**EL PASO WATER UTILITIES
PUBLIC SERVICE BOARD**

ADDENDUM NO. 2

**JOHN T. HICKERSON WRF
HEADWORKS BARSCREEN REPLACEMENT**

BID NO. 40-23

**MEZZANINE
EQUIPMENT
REPLACEMENT AND
REMOVAL**

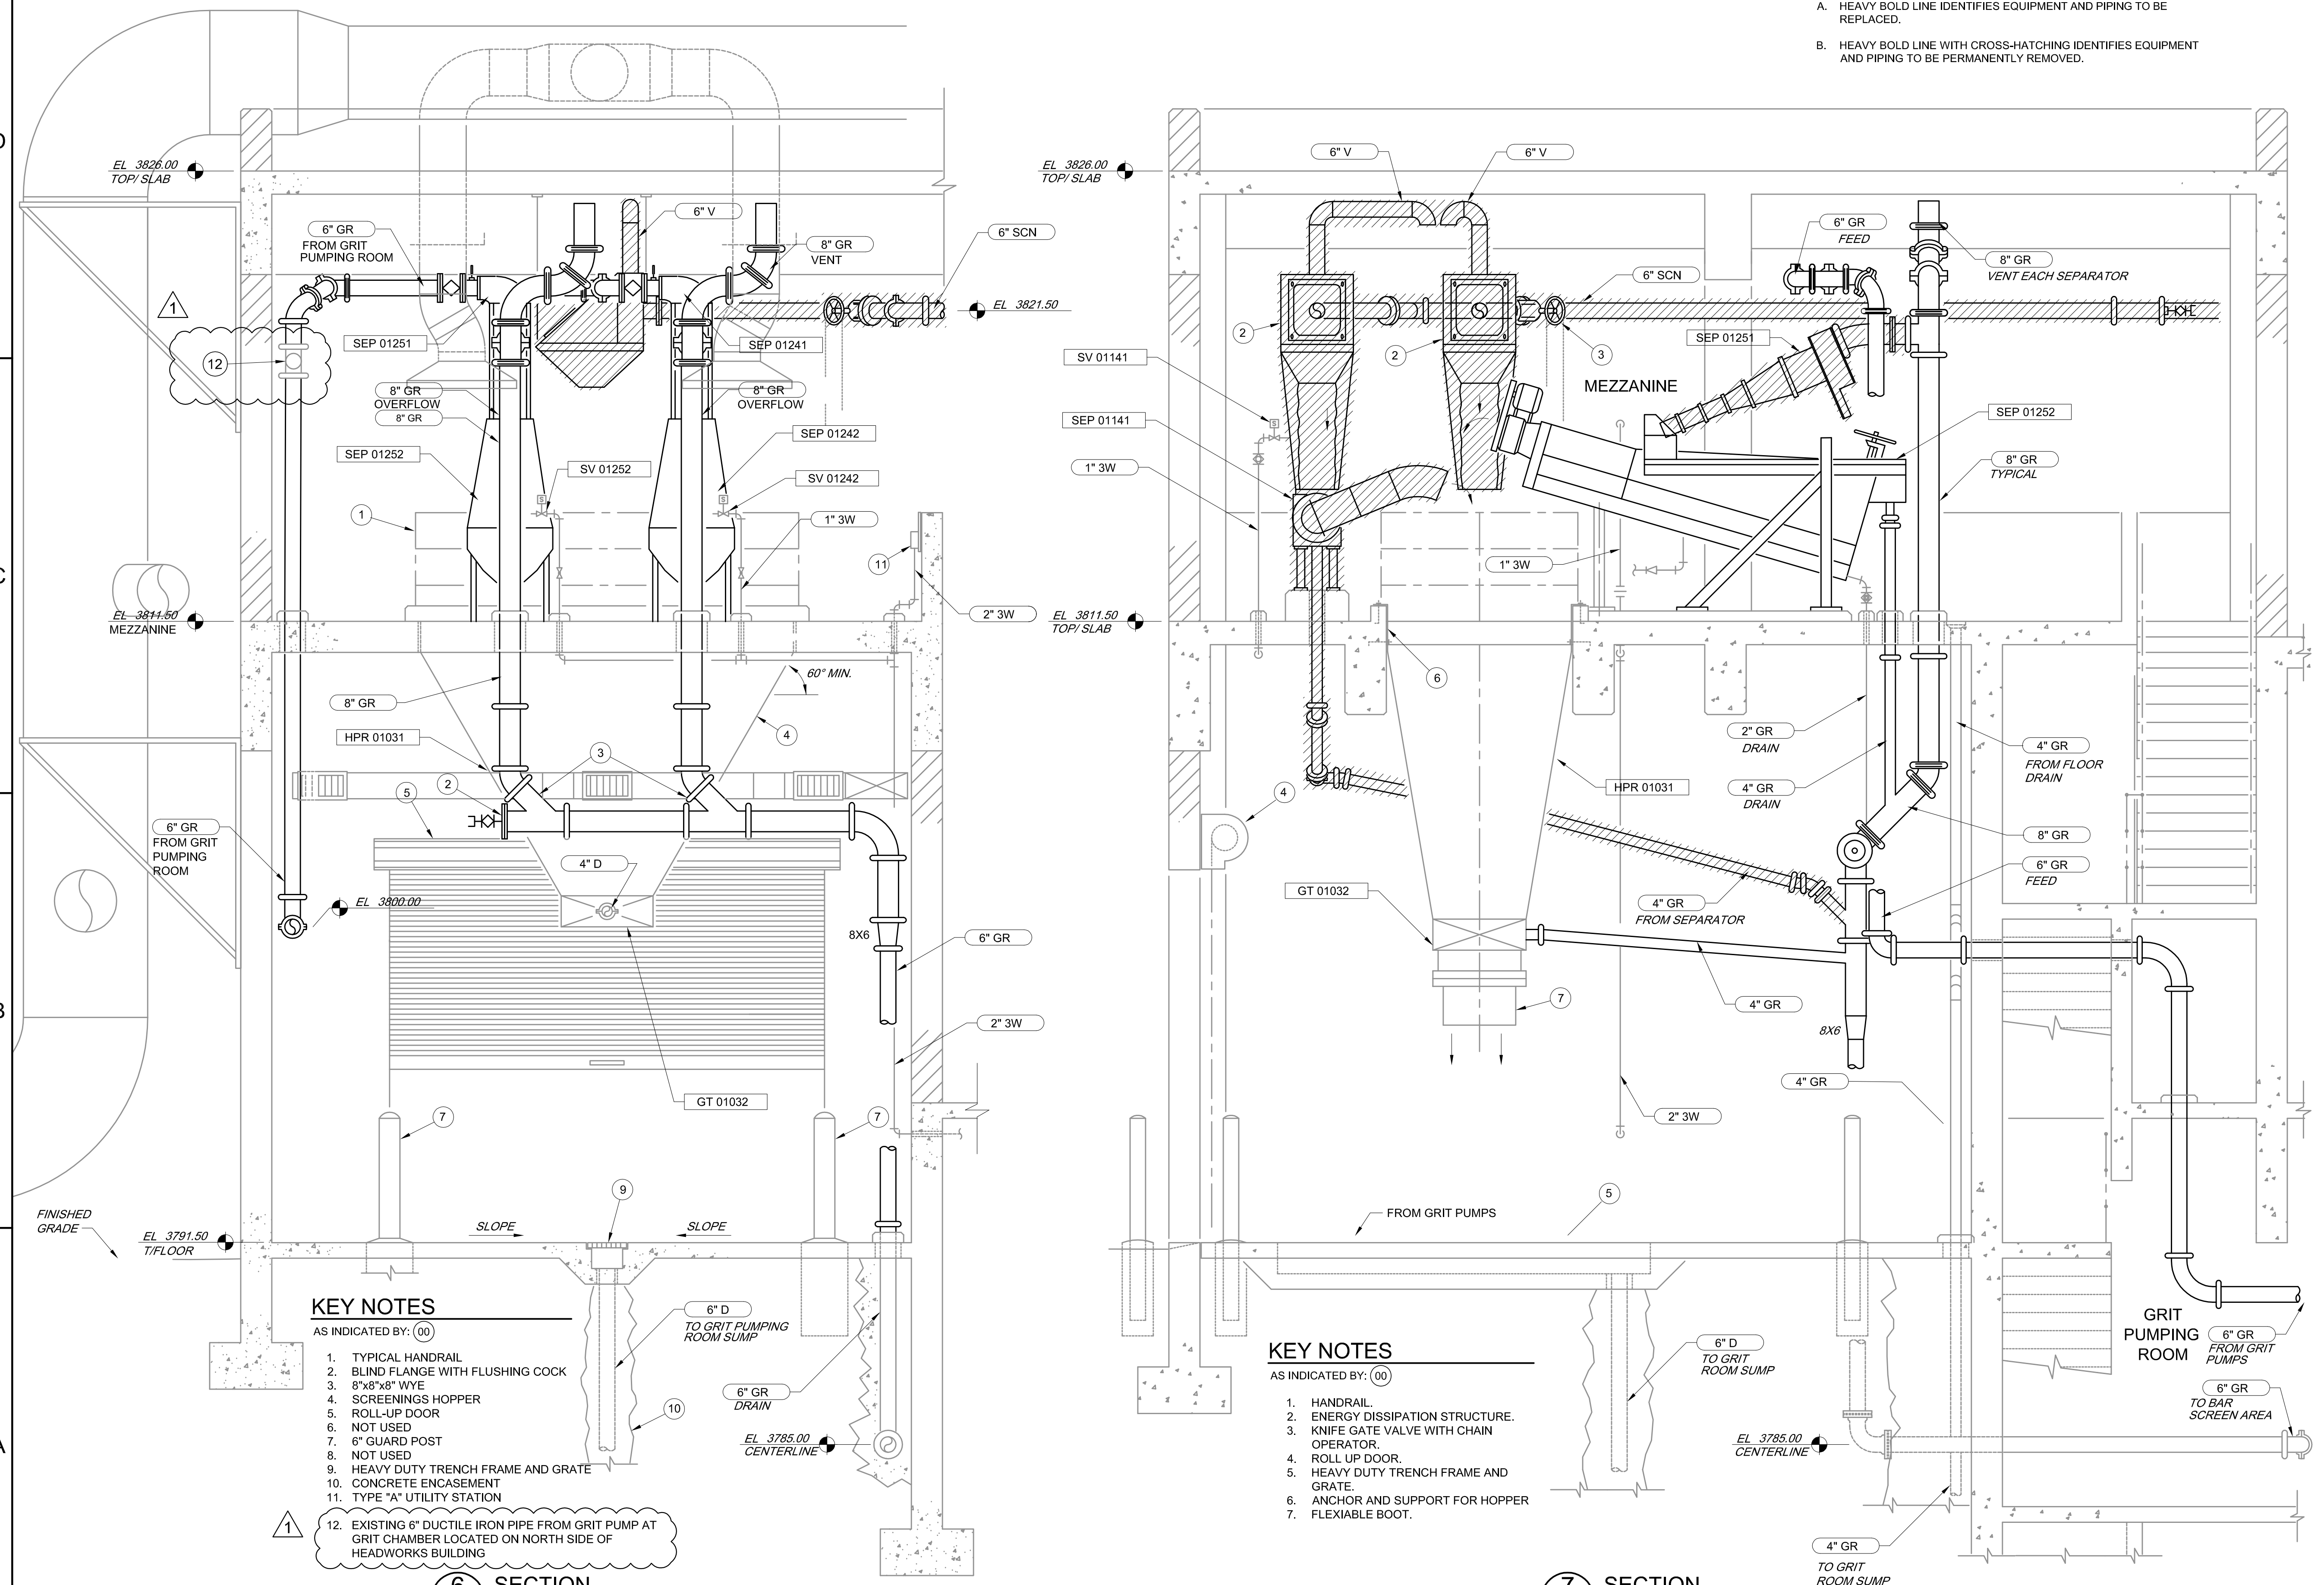
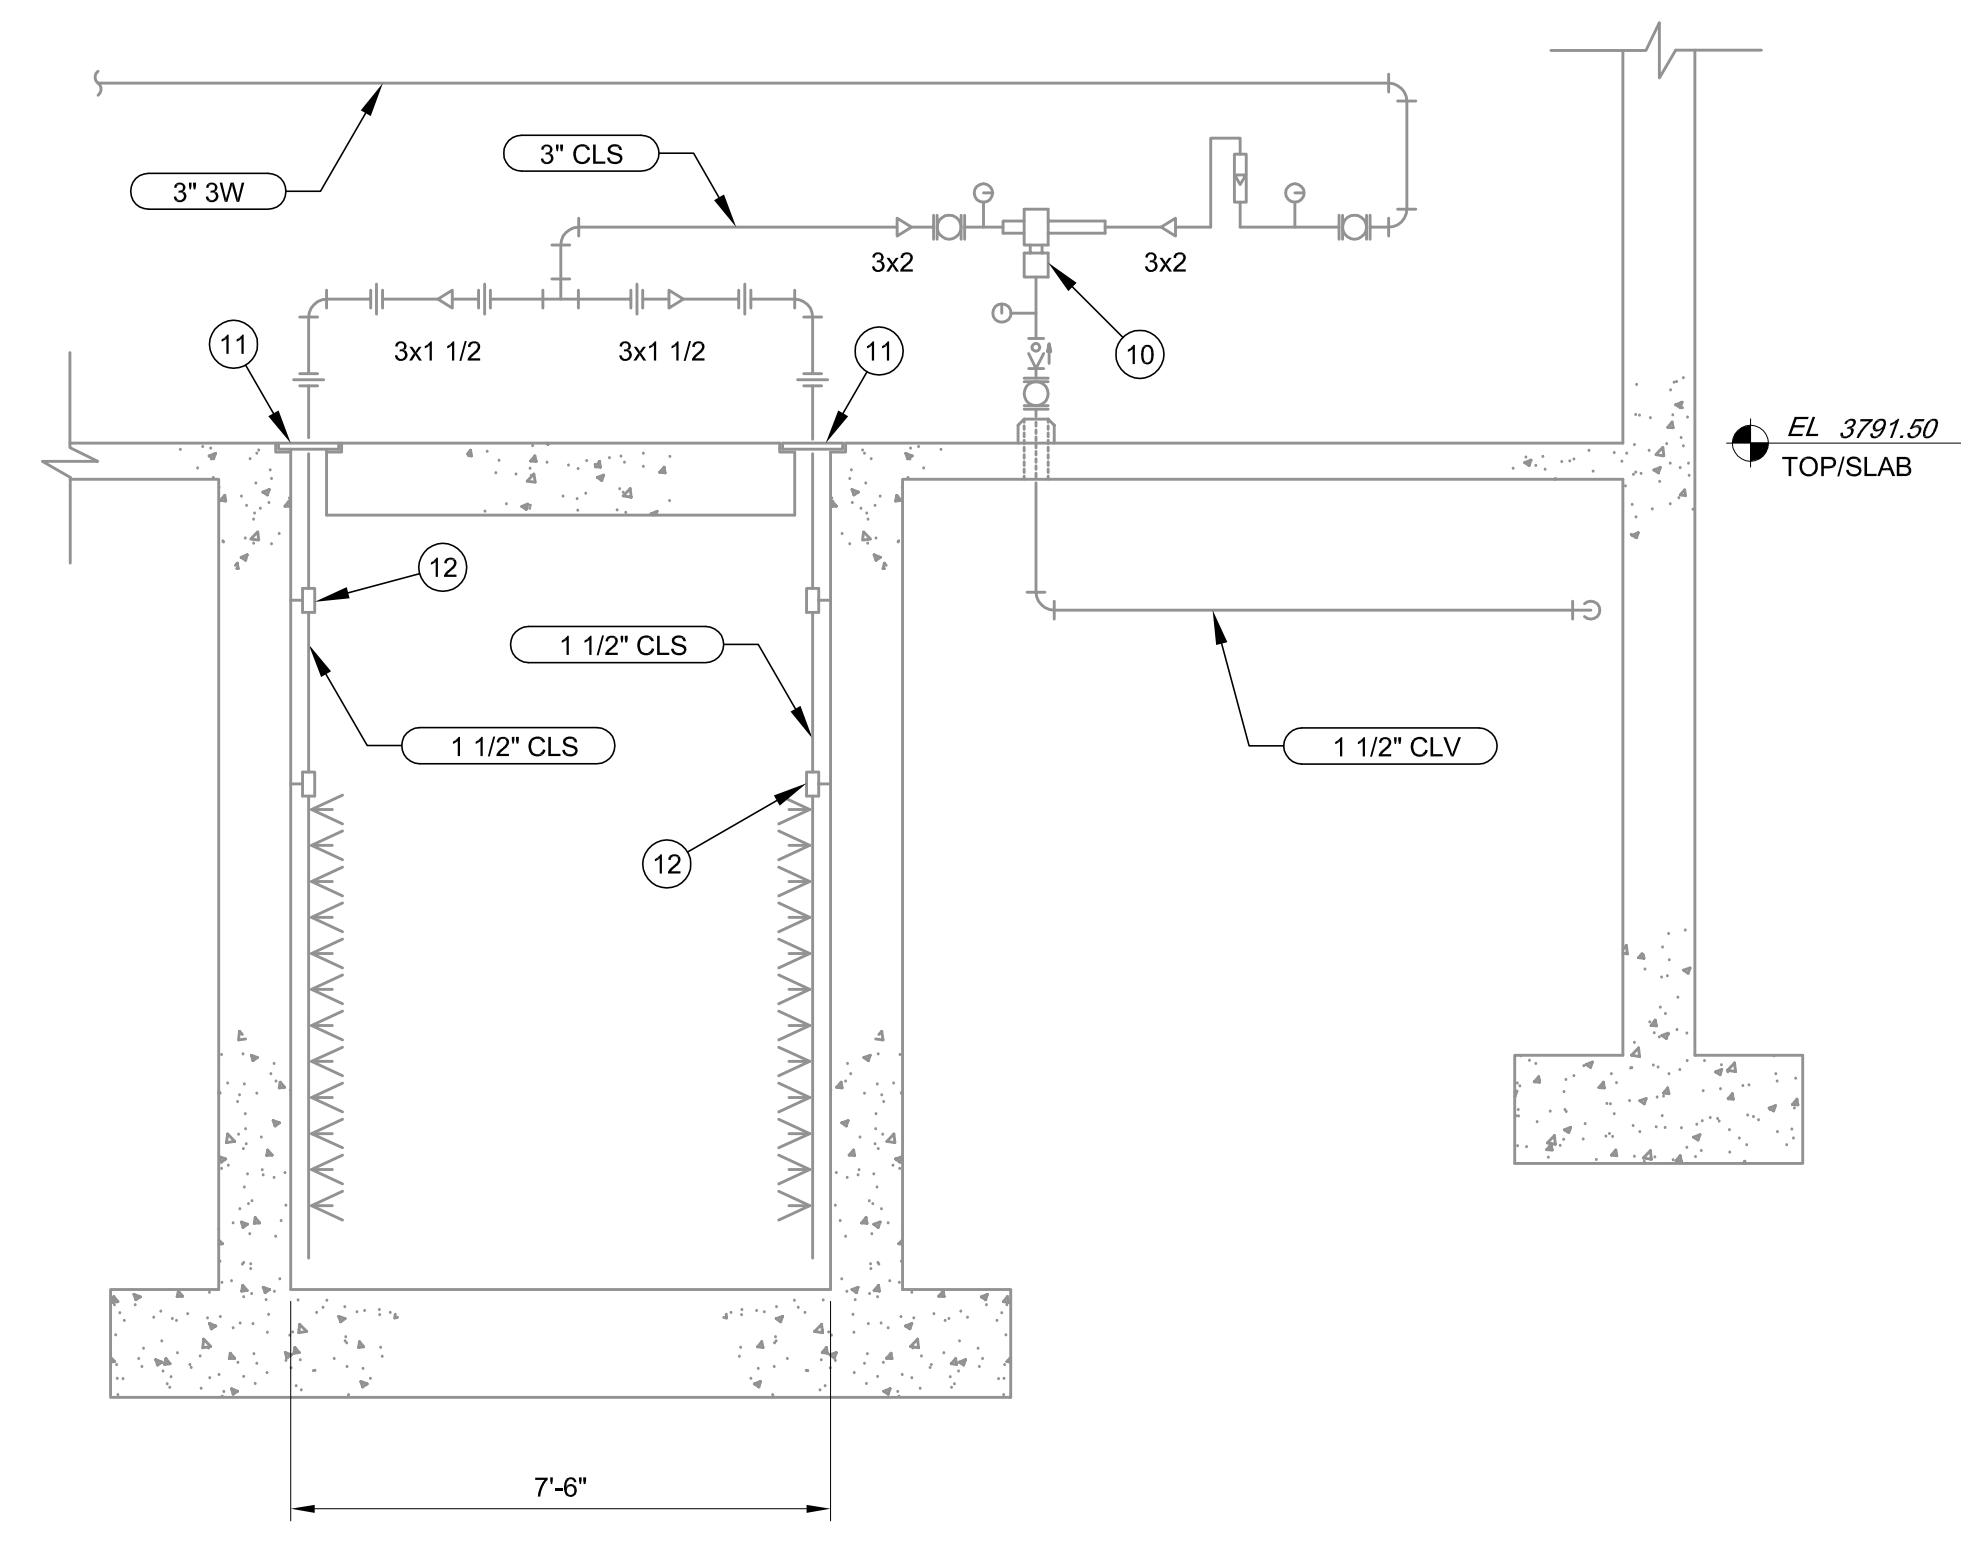
- AD-2.24. SHEET M113 – MEZZANINE EQUIPMENT REPLACEMENT AND REMOVAL
- A. REMOVE Sheet M113 in its entirety and REPLACE it with revised Sheet M113, attached to this Addendum. Keyed note added to identify size, material type, and function of existing grit pipe not being replaced.

13 SECTION
M108 SCALE: 3/8" = 1'-0"

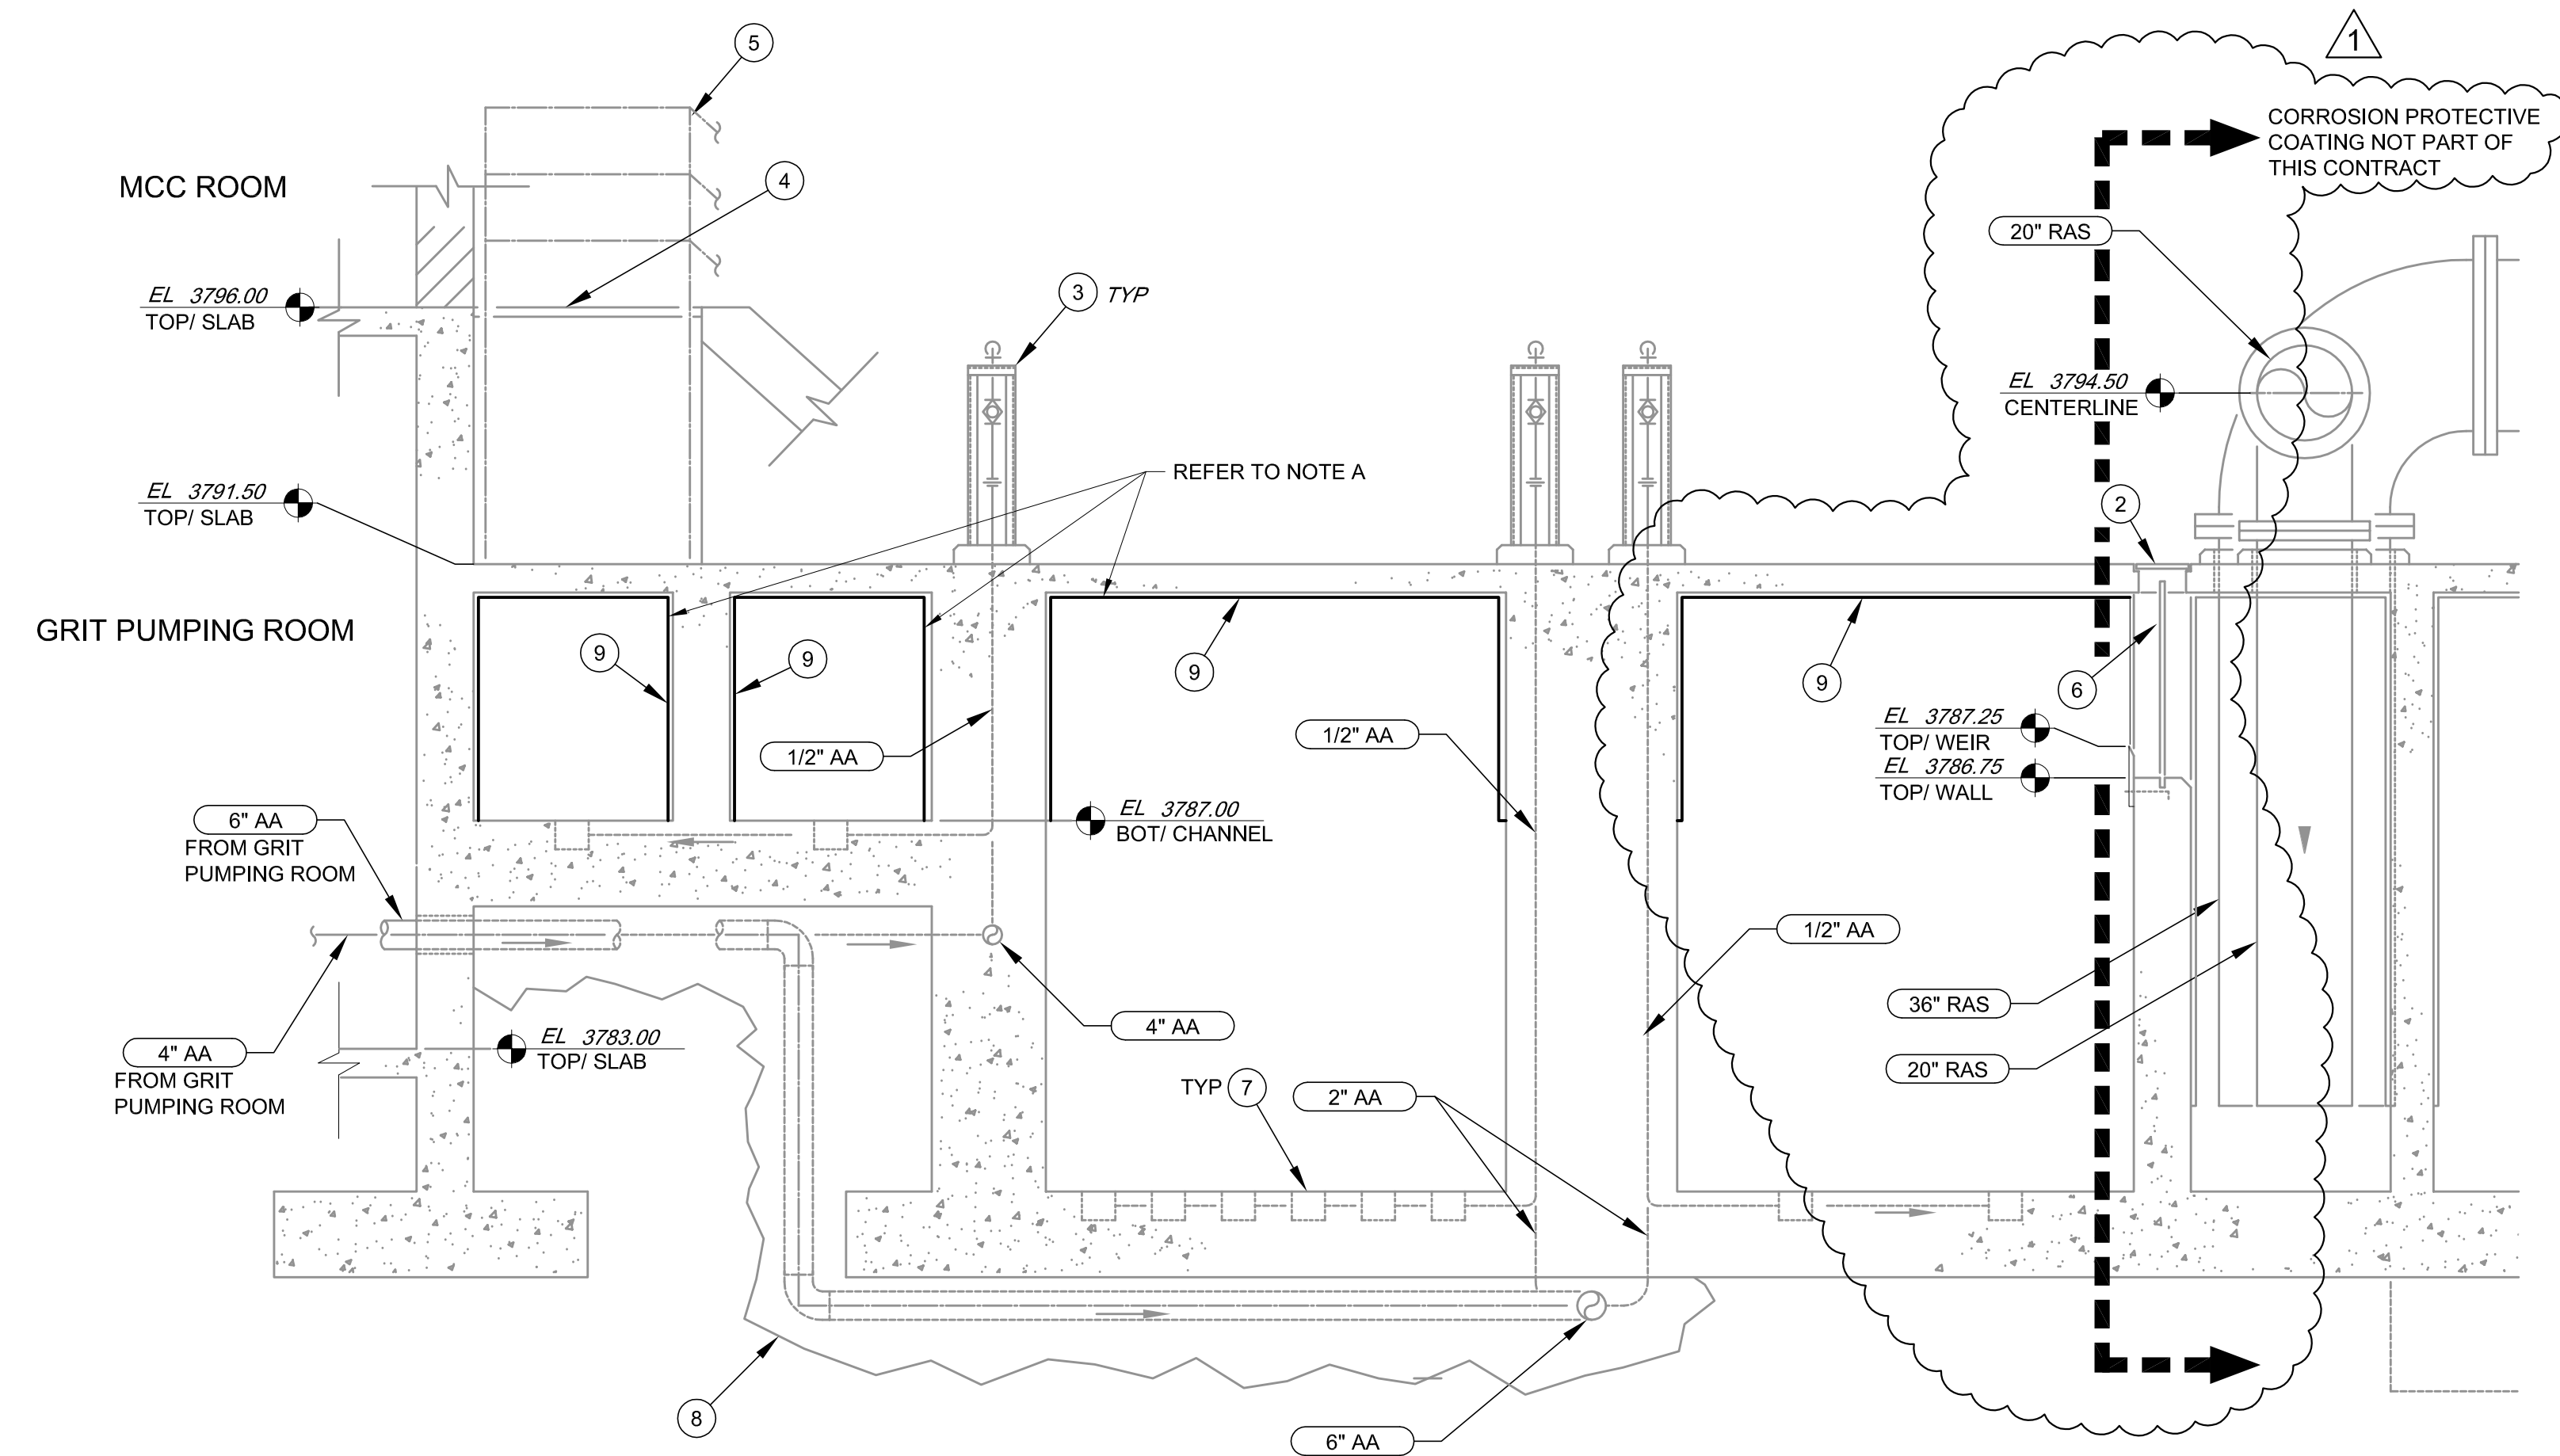
- AD-2.25. SHEET M116 – GRIT CHANNEL RELINING SECTION
- A. REMOVE Sheet M116 in its entirety and REPLACE with revised Sheet M116, attached to this Addendum. The limits of protective coating have been increased from what was shown previously.
